SUBJECT: Limerick Generating Station, Units 1 and 2
Technical Specifications Change Request No. 93-18-0
Response to Requests for Additional Information

"Increase the Allowable Leak Rate for the Main Steam
Isolation Valves and Delete the MSIV Leakage Control System"

RESPONSES TO QUESTIONS CONTAINED IN NRC LETTER DATED 5/6/94:

ATTACHMENT 1
GRAPH 1A

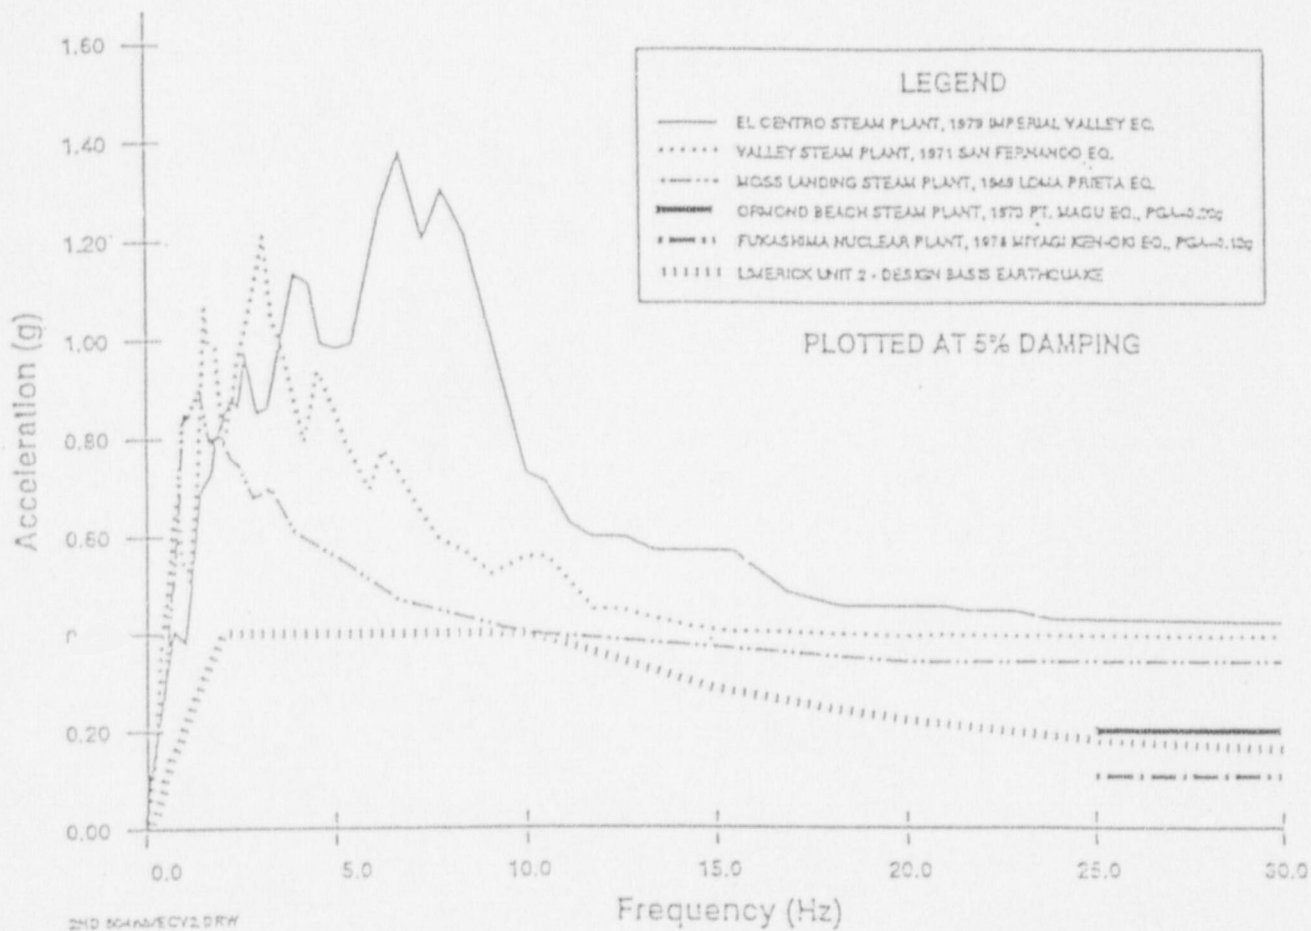
2. To ensure that the Limerick SSE design spectra are bounded by the experience database spectra, provide a plant-specific comparison of Limerick SSE Design Ground Response Spectra and the recorded ground motions at the selected earthquake database sites.

Three graphs, which are provided as Attachment 1, provide the comparison between the Limerick Response Spectra and the experience database spectra. Graph 1A provides a comparison of the Limerick horizontal ground response spectra to those experience data base spectra identified in NEDC-31585P Rev. 2. Graph 1B and 1C provide the comparison of the Limerick acceleration to

those contained in the supplemental experience database provided in Plant Hatch Letter HL #4468 dated 1/6/94. As shown in the attachments, the Limerick SSE acceleration is well bounded by the experience database acceleration.

ATTACHMENT 2
FIGURE 2A

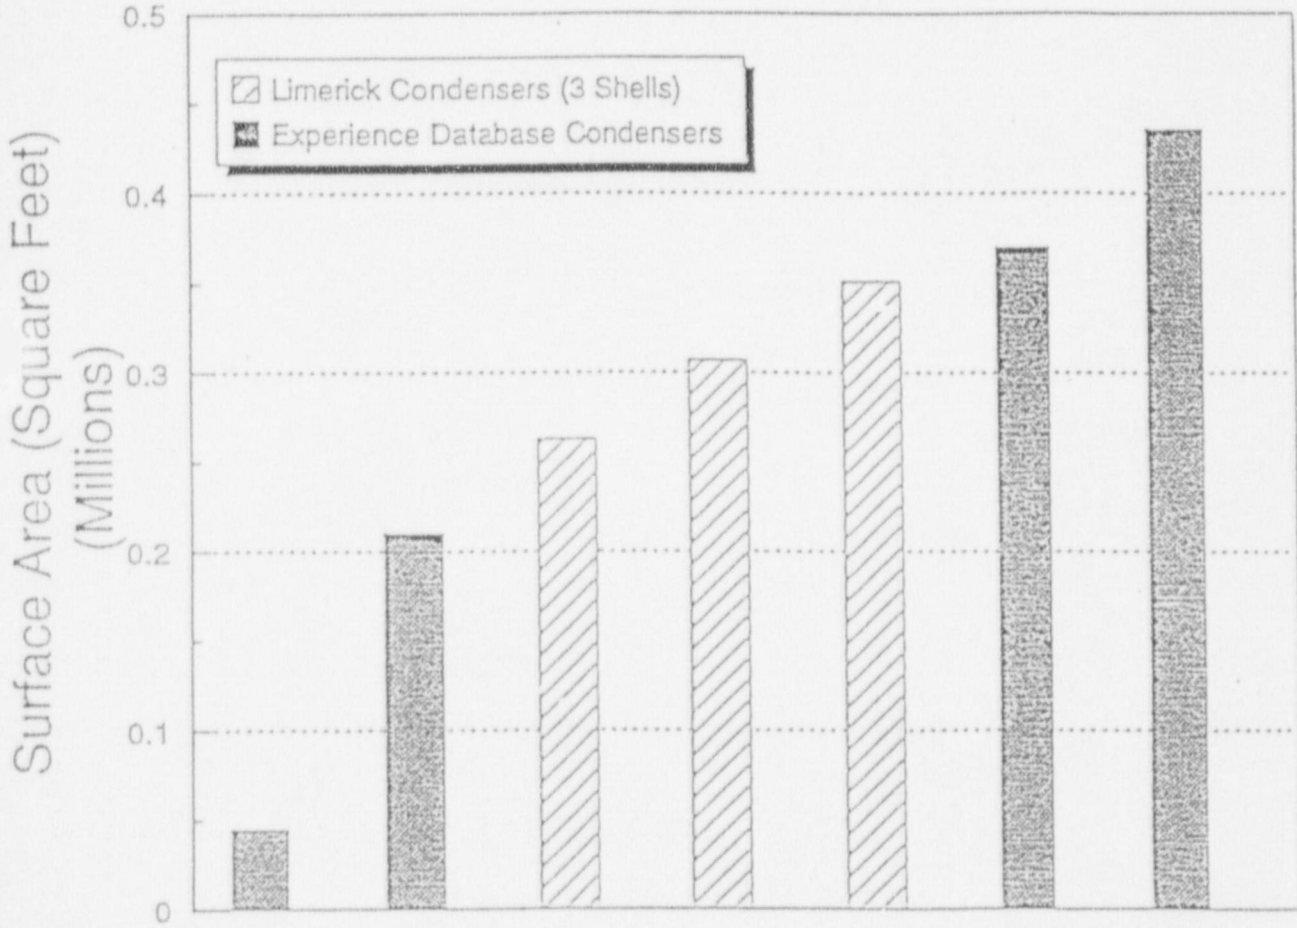
4. Provide a plant specific comparison for design attributes of the Limerick main condenser and those in the experience database, including condenser size, weight, height, footprint, and anchorage capacity.

As stated in TS Change Request 93-18-0, an evaluation of the LGS main condenser found that it is comparable to those in the seismic experience database contained in NEDC 31585P Rev. 2. The following information is provided to demonstrate the acceptability of the Limerick Main Condenser Design:

1. The Limerick condenser was constructed by Foster Wheeler and is a triple shell, triple pressure condenser built to the following design and construction codes:
 - American Society of Testing and Materials (ASTM)
 - Heat Exchanger Institute (HEI)
 - American National Standards Institute (ANSI)
2. The overall condenser surface area falls within the sizes of the condensers in the seismic experience database as demonstrated by Figure 2A of Attachment 2.
3. The condenser's ability to resist seismic demand is demonstrated through Figures 2B and 2C, which show that the condensers' shear area/seismic demand exceeds those contained in the seismic database.

This information supports the conclusion, previously stated in TS Change Request 93-18-0, that the Limerick Main Condenser is seismically rugged and is comparable to those condensers which have shown to be capable of withstanding a Seismic Event.
